Unisense Apparels Ltd (Extension)

Beraider Chala, Sreepur, Gazipur
(24.20003, 90.42065)

26th January 2021

Observations: Boiler & Compressor Room

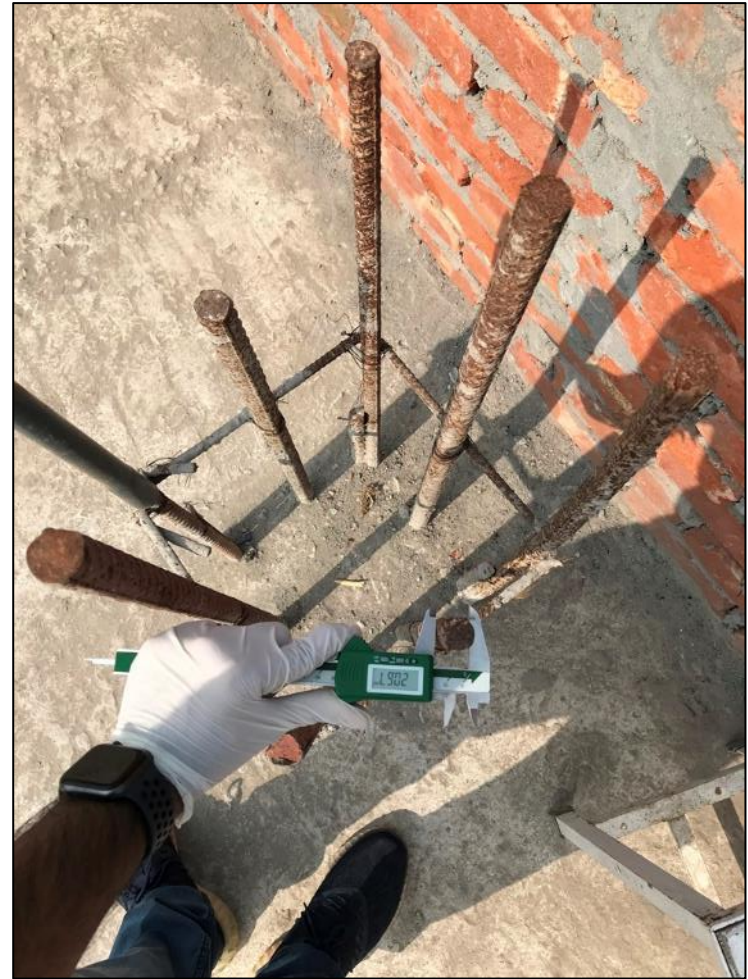
As-built drawings not available onsite

No as-built drawings were available onsite. Building engineer is required to prepare as-built drawings.
